Re: Turkey Point Units 3 and 4  
Docket Nos. 50-250 and 50-251  
Response to NRC Request for Additional Information Regarding  
Extended Power Uprate License Amendment Request No. 205 and Nuclear  
Performance and Code Review Issues

Turkey Point Units 3 and 4  
RESPONSE TO NRC RAI REGARDING EPU LAR NO. 205  
AND NUCLEAR PERFORMANCE AND CODE REVIEW ISSUES

Response to Request for Additional Information

**Figure SNPB-1.2.1k-1**  
**LBLOCA Scenario (14.7 psia) : Sump Boric Acid Concentration vs. Time**

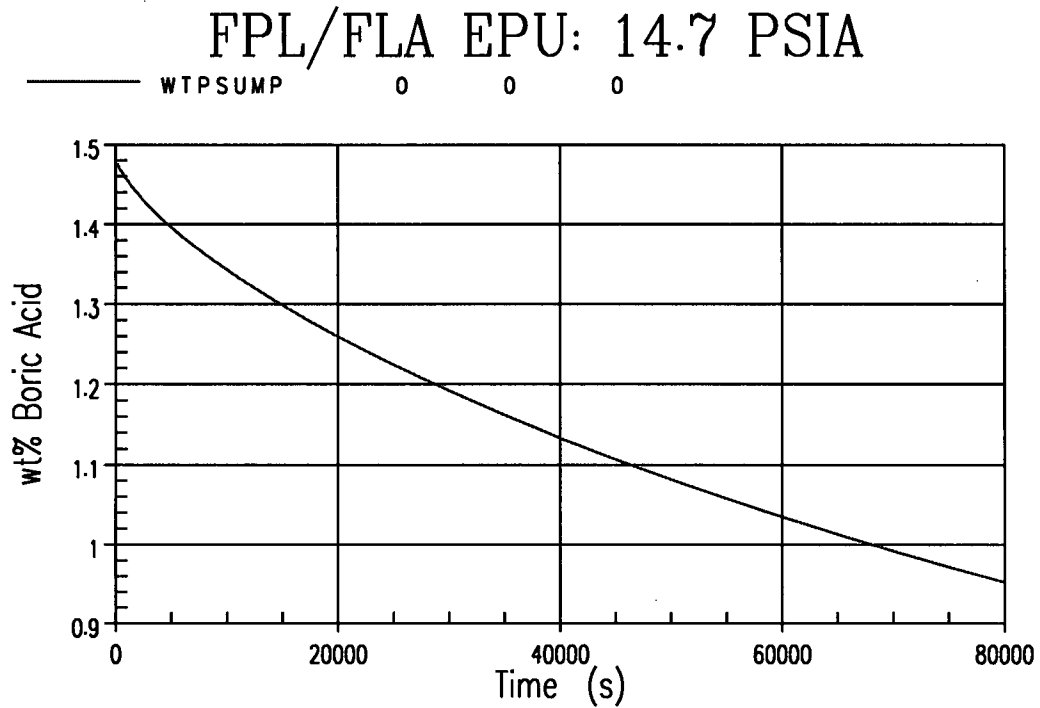
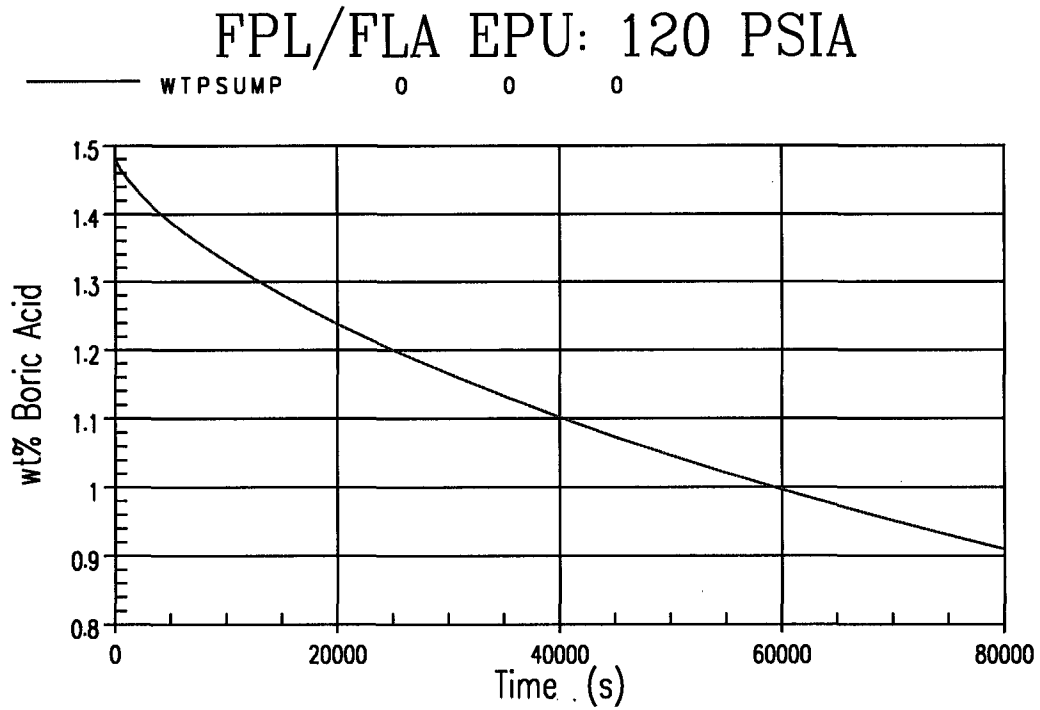
**k. Sump boric acid concentration vs. time.**

The sump boric acid concentration vs. time is shown in Figure SNPB-1.2.1k-1 for the

LBLOCA scenario (14.7 psia) and Figure SNPB-1.2.1k-2 for the SBLOCA scenario (120 psia).

Figure SNPB-1.2.3-1  
Limiting Bottom Skewed Power Shape for Average Power Rod

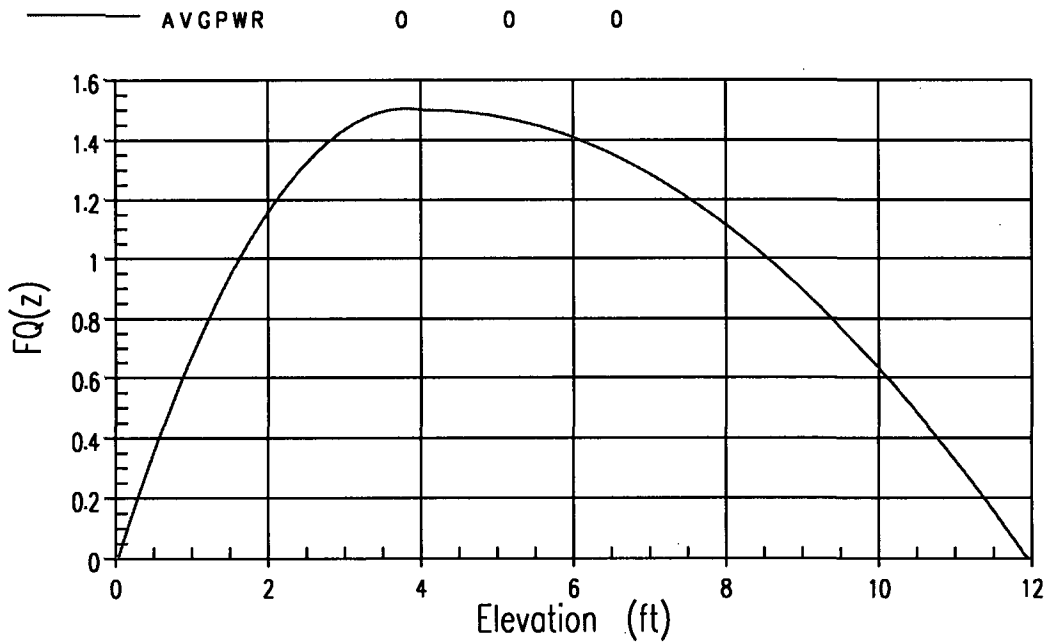
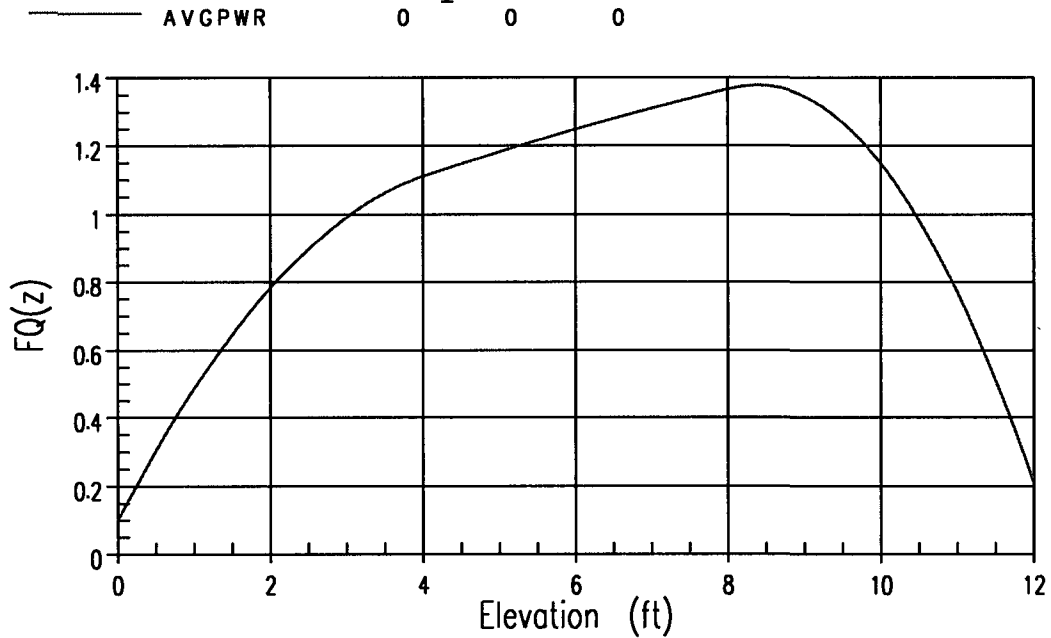
**SNPB-1.2.3 Provide the limiting bottom and top skewed axial power shapes.**

The limiting Best Estimate LOCA (BELOCA) bottom skewed power shape is shown in Figure SNPB-1.2.3-1 with an axial offset of -17.054%. The limiting BELOCA top skewed power shape is shown in Figure SNPB-1.2.3-2 with an axial offset of 12.325%. Table SNPB-1.2.3-1 depicts the tabular data that is presented graphically in Figure SNPB-1.2.3-1 and Figure SNPB-1.2.3-2.

**Figure SNPB-1.2.4-1**  
**Core Mixing Volume and Void Fraction vs. Time for the LBLOCA Scenario (14.7 psia)**

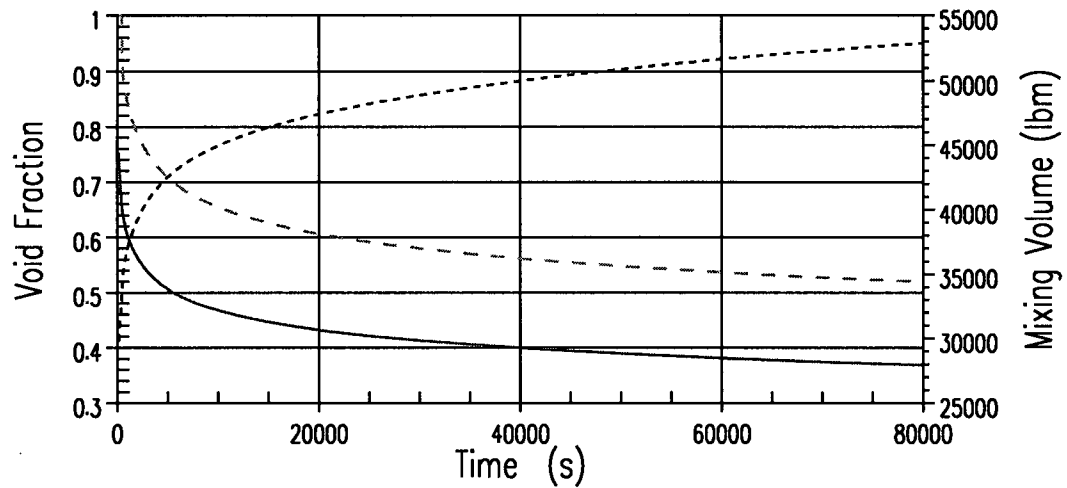
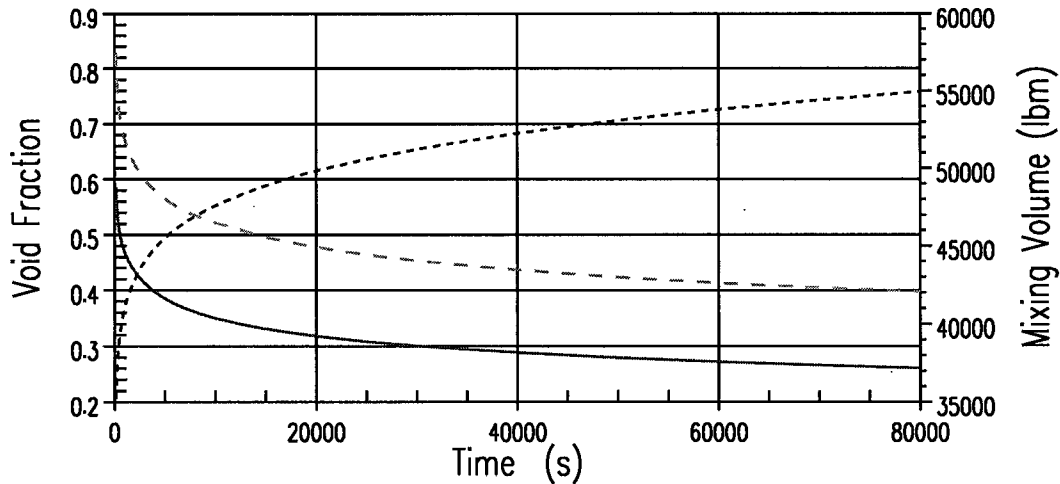
**SNPB-1.2.4 Provide the mixing volume vs. time.**

The mixing volume vs. time for both the large break (14.7 psia) and small break (120 psia) post-LOCA scenarios are presented in Figures SNPB-1.2.4-1 and Figure SNPB-1.2.4-2 respectively. The core average void fraction and upper plenum (i.e. exit) void fraction have also been included for completeness.

**Figure SNPB-1.2.5-1**  
**Mass Calculations in SKBOR**

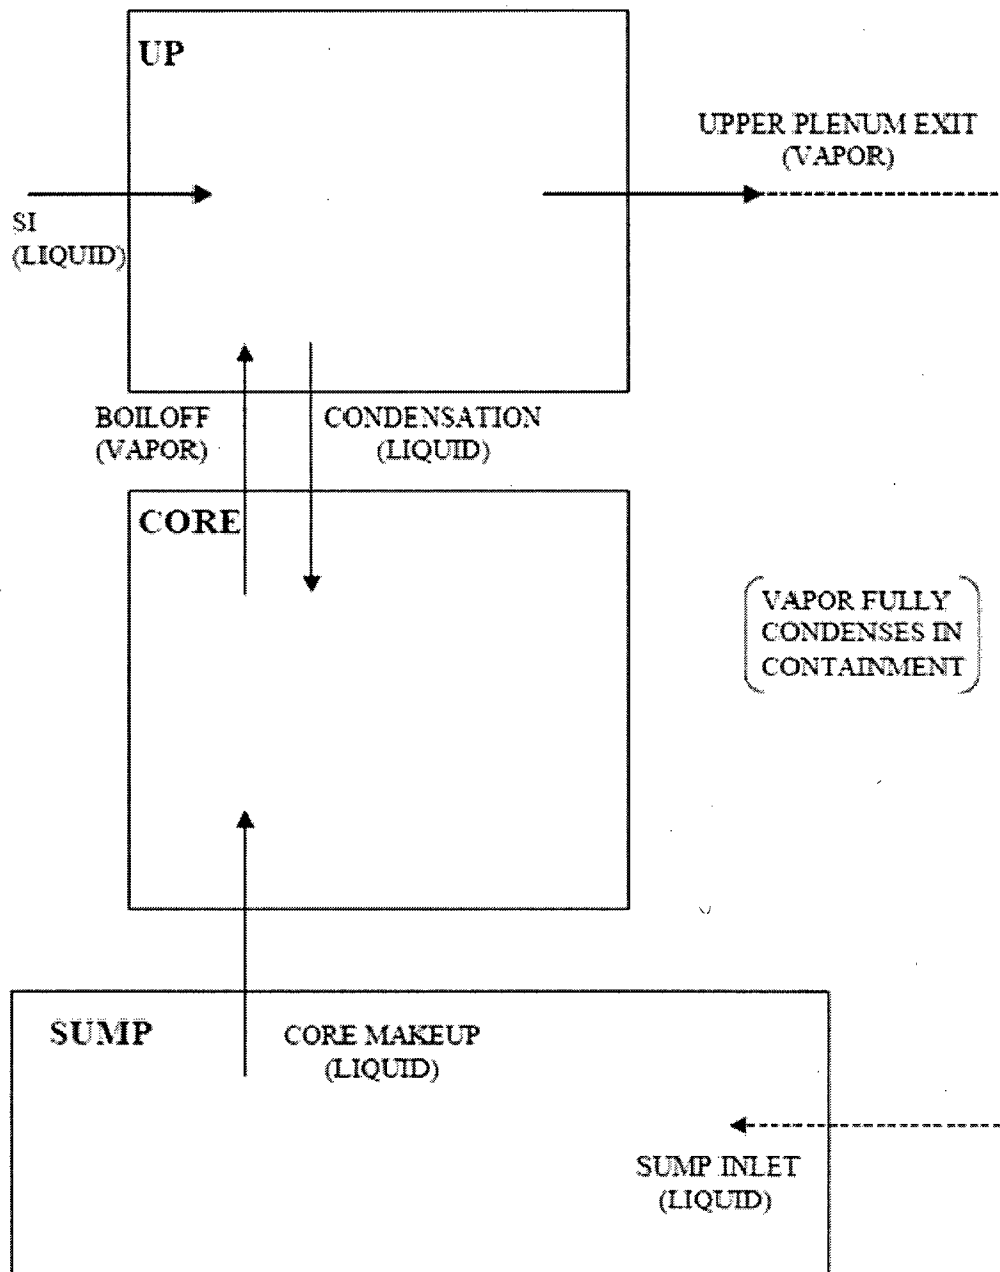
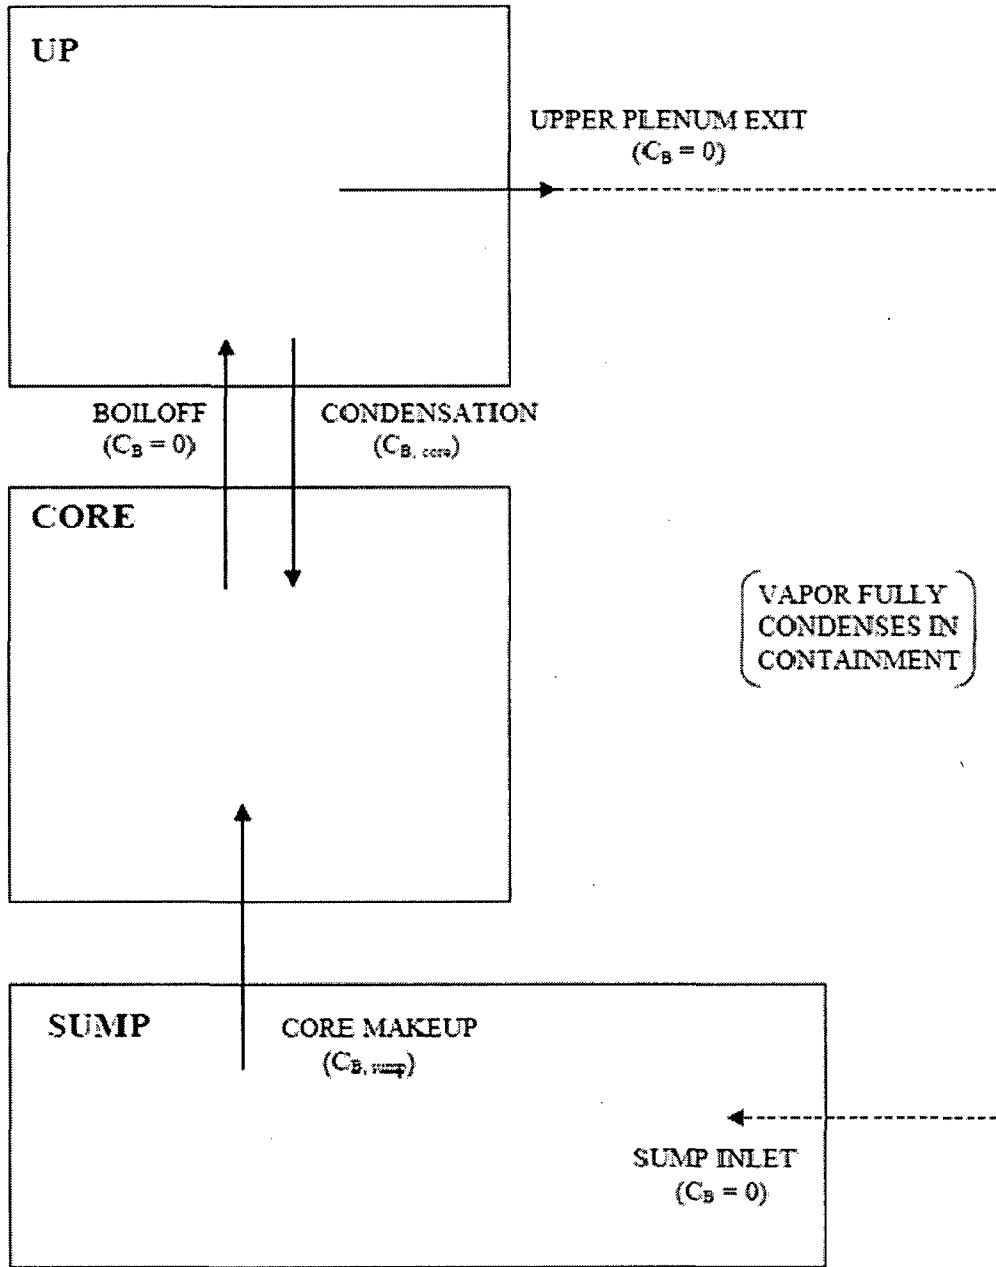
### **SNPB-1.2.5 Justification and description of the methodology used to compute the sump boric acid concentration vs. time.**

A typical SKBOR calculation considers two volumes: one representing the effective vessel mixing volume (denoted as the CORE), and one representing the remaining system inventory (denoted as the SUMP). The CORE and SUMP are initially assumed to contain borated liquid at the system-average boric acid concentration. Vapor generated due to decay heat boiling exits the CORE with a boric acid concentration of zero (vapor is assumed to condense fully in containment) and is returned to the SUMP as unborated liquid. Borated liquid is added from the SUMP as required to keep the CORE volume full. In this way, the SUMP boric acid concentration gradually decreases, while the CORE boric acid concentration increases toward the boric acid solubility limit. The logic of the mass and boric acid calculations in SKBOR is shown in Figures SNPB-1.2.5-1 and SNPB-1.2.5-2.
